Wisconsin Department of Transportation

Proposal #11: 1228-03-76, WISC 2025366
IH 43 North South Freeway
Oak Leaf Trail to Bender Road
IH 43
Milwaukee County

This is Addendum No. 02, which provides for the following:

1	3/5/25	ADDED SPV FOR PANEL REPAIR	TAB
NO.	DATE	REVISION	BY
STATE OF WISCONSIN DEPARTMENT OF TRANSPORTATION			
STRUCTURE R-40-159			
	DRAWN BY	PLANS	WCD
	VC1	CHD.	
SHEET 4 OF 12			466
QUANTITIES & NOTES

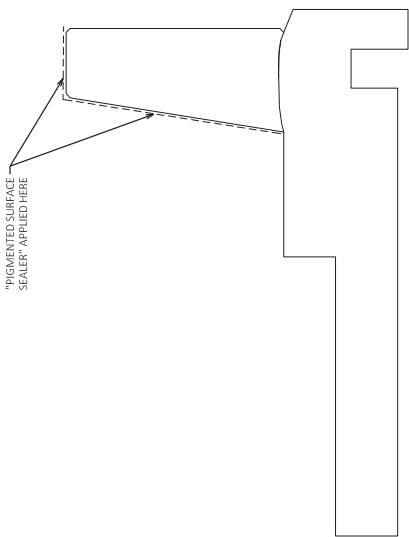
Revised: 49, 212, 216, 464-466, 475

505.0600	BAR STEEL REINFORCEMENT 15 COATED STRUCTURES	LB	163490
509+1500	CONCRETE SURFACE REPAIR	SF	200
509.3020.5	EPOXY CRACK SEALING	LF	100
516.0500	RUBBERIZED MEMBRANE WATERPROOFING	SF	85

653.0220	JUNCTION BOXES 18X126X6-INCH	EACH	11
653.0222	JUNCTION BOXES 18X126X6-INCH	EACH	5
SPV.0060	ANCHOR ASSEMBLIES NOISE BARRIER STRUCTURES R-40-159	EACH	258
SPV.0090	JOINT SEALING	LF	200
SPV.0165	WALL PANEL CONCRETE SURFACE REPAIR	SF	200
	NON-BID ITEM		
	NON-BITUMINOUS JOINT SEALER	SIZE	3/4", 1"
	FILLER	SIZE	3/4", 1 1/2"
	CORK FILLER	SIZE	1"
	EXPANDED POLYSTYRENE	SIZE	1"

Addendum No. 02
ID 1228-03-76
Revised Sheet 475
March 7, 2025

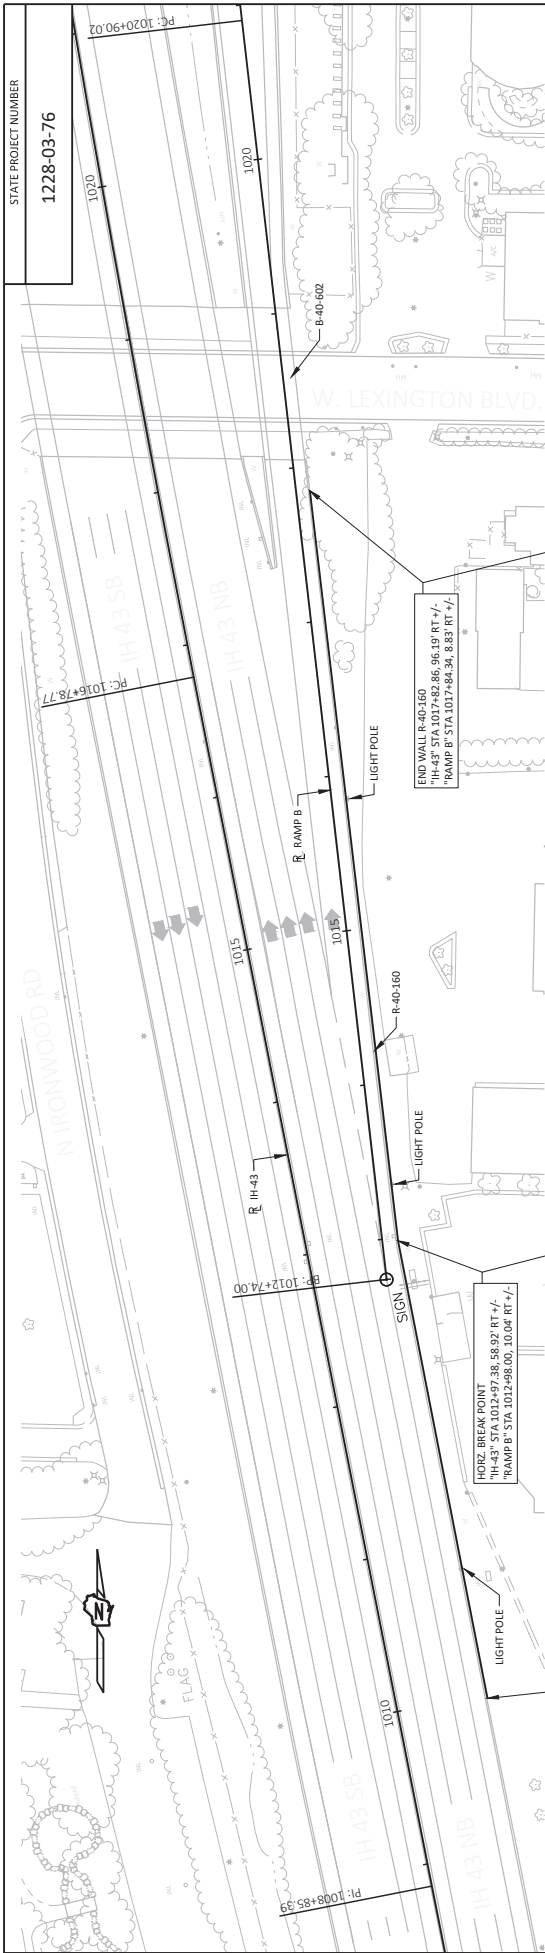
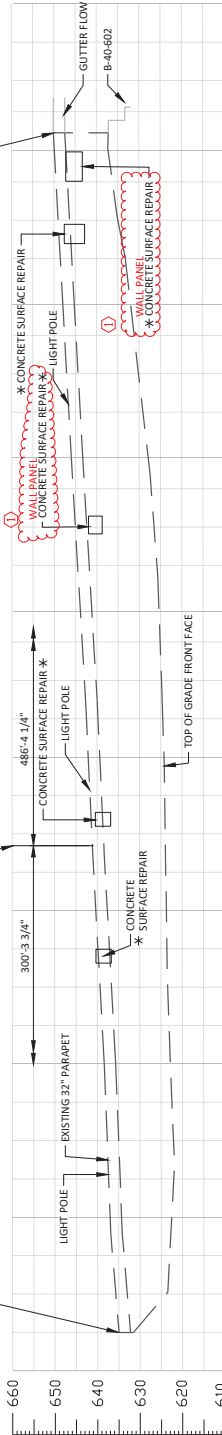
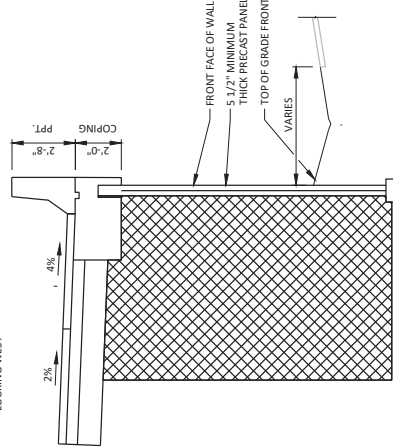
Revised Plan Sheets	
Plan Sheet	Plan Sheet Title (brief description of changes to sheet)
49	Updated plans to change mix seeding mix to No. 70
212	Miscellaneous Quantities (updated Seeding Mixture No. 30, Seed Water and added Seeding Mixture No.70)
216	Miscellaneous Quantities (updated Traffic Control Local Road Lane Closures)
464	Updated label to Wall Panel Concrete Surface Repair
465	Updated label to Wall Panel Concrete Surface Repair
466	Updated quantities to include Wall Panel Concrete Surface Repair
475	Updated labels and quantities to show Wall Panel Concrete Surface Repair

NO.	DATE	REVISION	BY
1	3/3/25	ADDED SPV FOR PANEL REPAIR	TAB

TOTAL ESTIMATED QUANTITIES			
ITEM NUMBER	BID ITEM	UNIT	TOTAL
509.1500	CONCRETE SURFACE REPAIR	SF	10
SPV.0090	JOINT SEALING	LF	300
SPV.0165	WALL PANEL CONCRETE SURFACE REPAIR	SF	10
